M54 to M6 Link Road TR010054

8.8 LIU(E) Draft Statement of Common Ground with Mark Commins & Tracey Commins

**8.8 LIU(E) Draft Statement of Common Ground with
Mark Commins & Tracey Commins**

Regulation Number	Regulation 5(2)(q)
Planning Inspectorate Scheme Reference	TR010054
Application Document Reference	8.8 LIU(E)
Author	M54 to M6 Link Road Project Team and Highways England

Drawing Title
**FENCING
SHEET 5 OF 10**

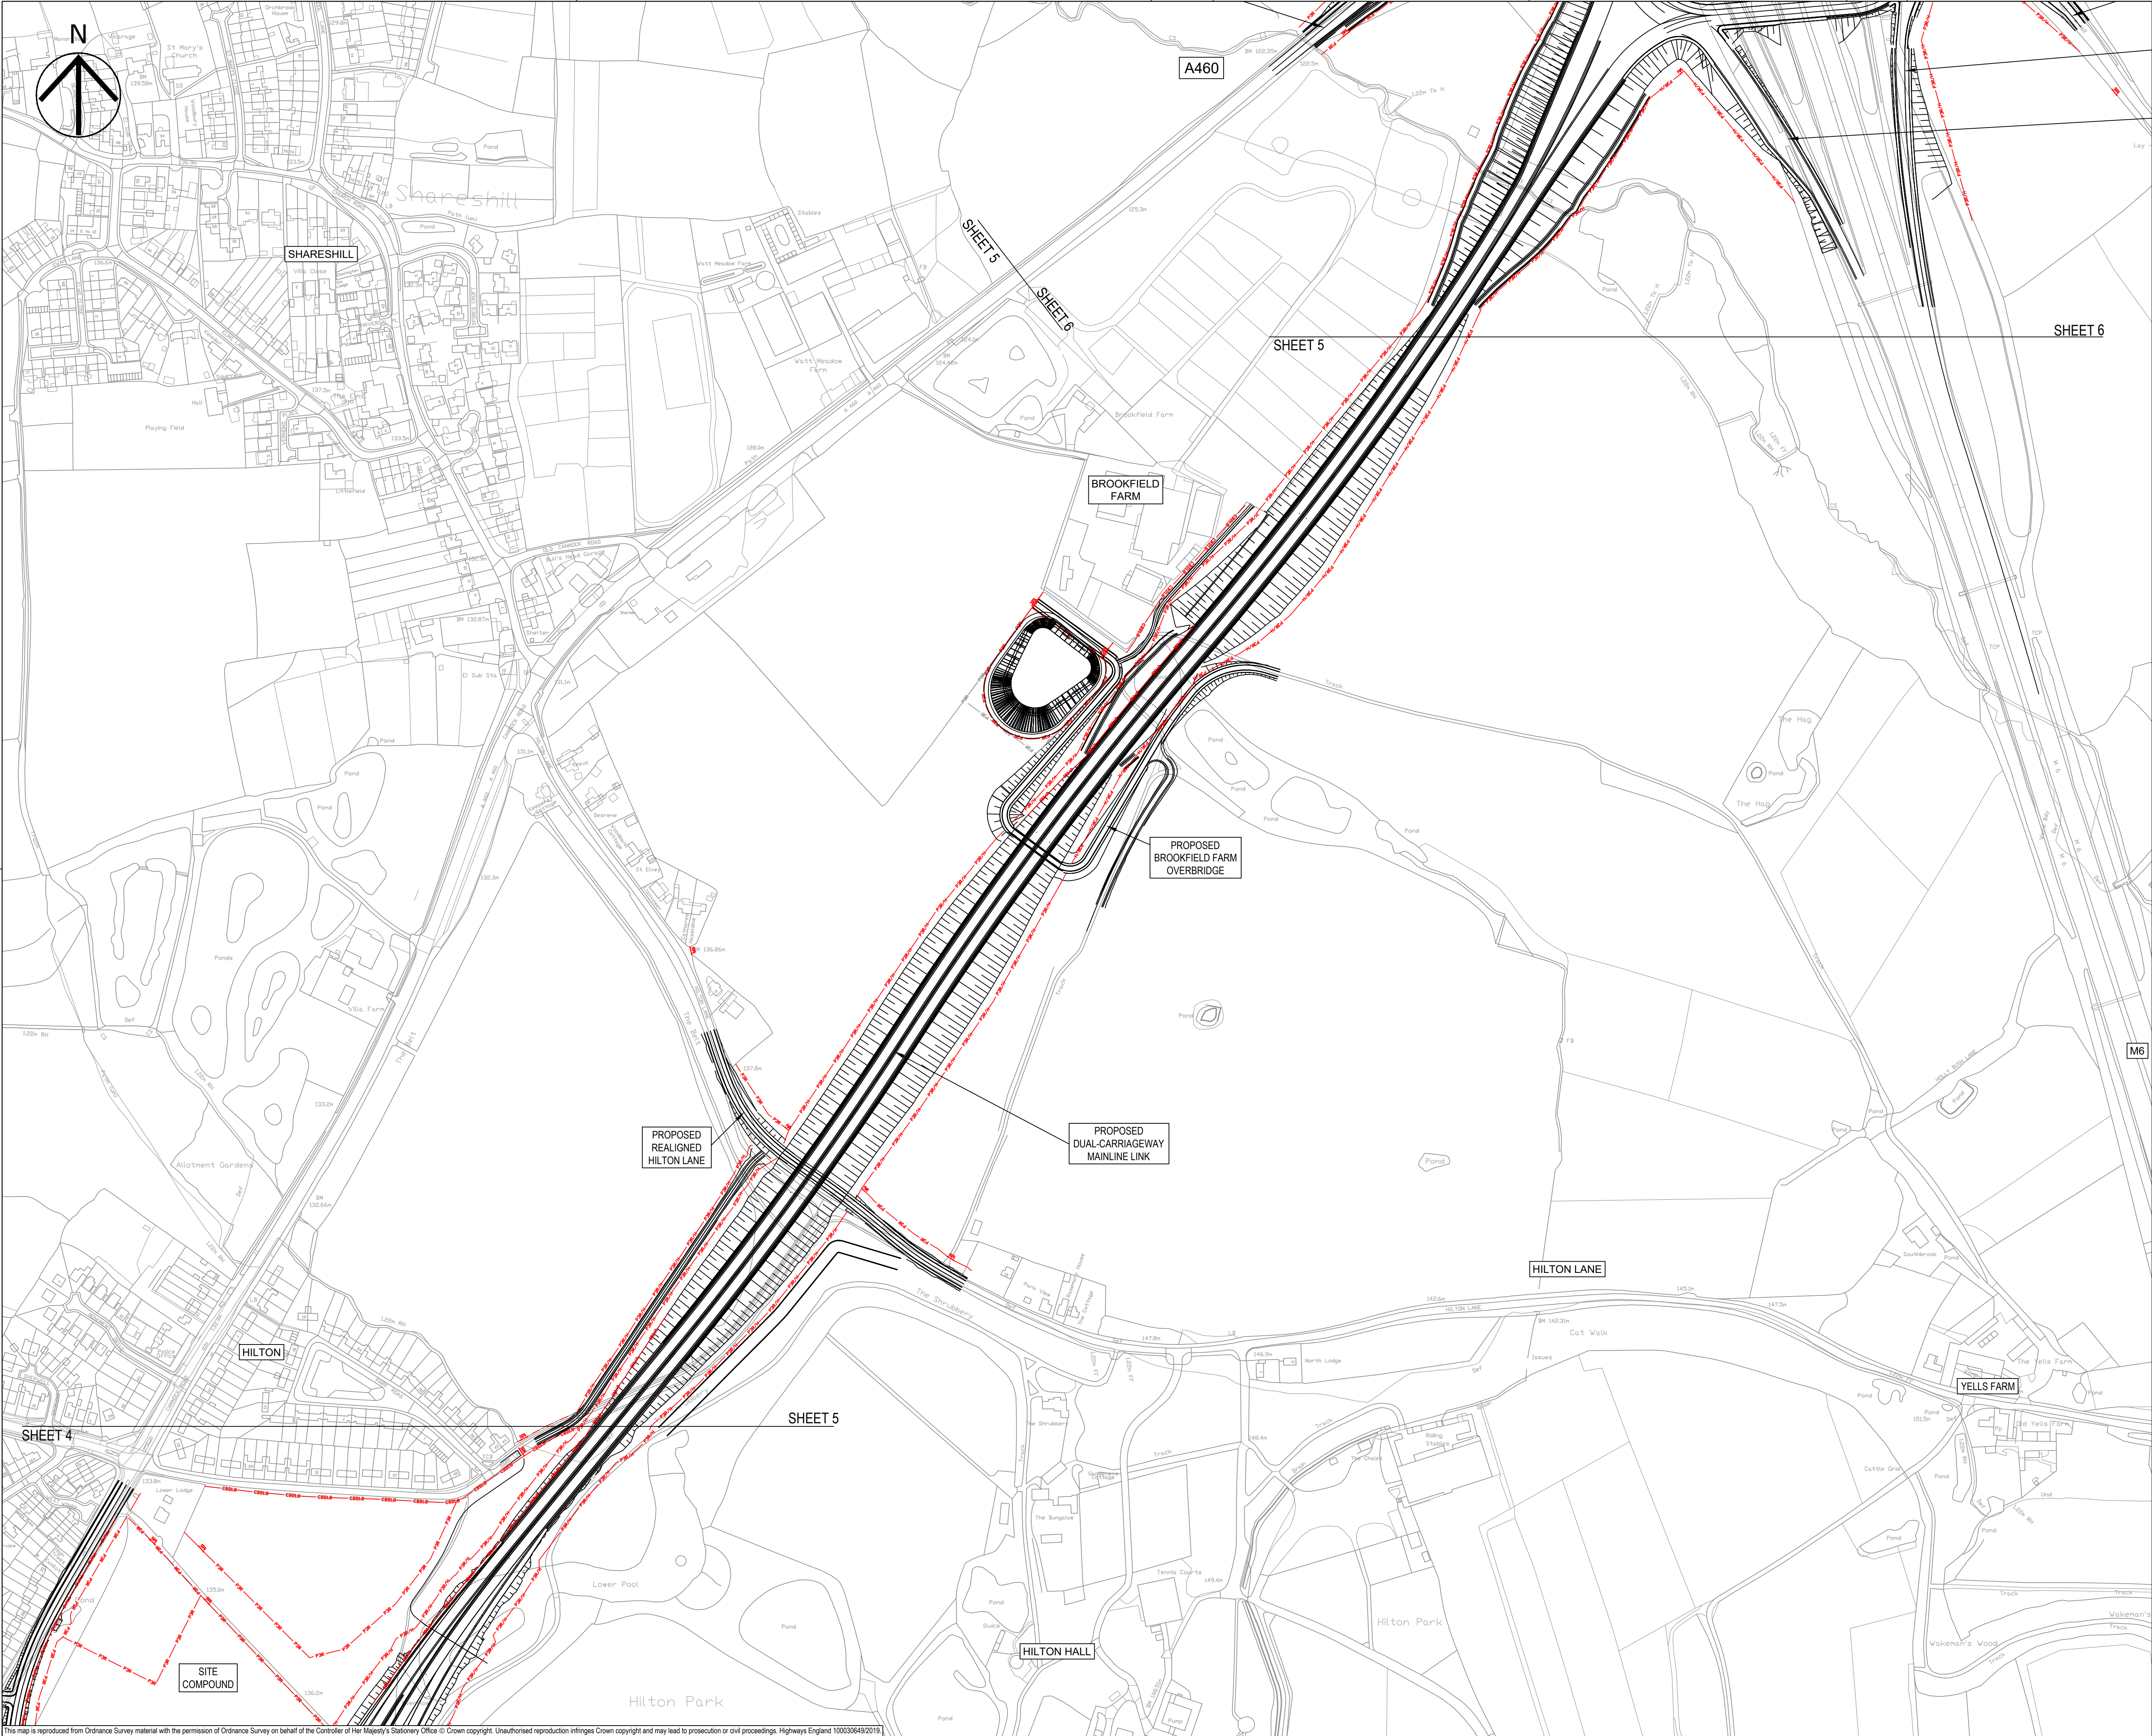
Issue	Landowner comment	Highways England Response	Status	Agreement likely (app) ¹	Agreement likely (IP)
		<p>the low point of existing topography close to the existing discharge point of the ditch.</p> <p>Further detail of the drainage outfall location is provided on the Outline Drainage Works plans provided with the Application documents [TR010054/APP/2.11] (issued as part of the DCO Application on 30/01/20).</p>			
Diverted public right of way	Location and perceived security risk of the diverted public footpath	<p>Any alternative routes for the footpath would require greater land take within Brookfield Farm to provide an accommodation over bridge closer to the existing route. The current location has been chosen in order to reduce the land take within the farm and accommodate users onto the new bridge south of Brookfield Farm. This means it is necessary to divert users along the back of Brookfield Farm.</p> <p>Highways England proposes to install closed boarded fencing at 1.8 metre in height alongside the right of way to address concerns raised by the landowner. See Appendix B for the fencing drawing (Ref [HE514465-ACM-HFE-Z2_SW_PR_Z-DR-CH-1005])</p> <p>Details of boundary features will be discussed as part of ongoing dialogue.</p>	Under discussion	Medium
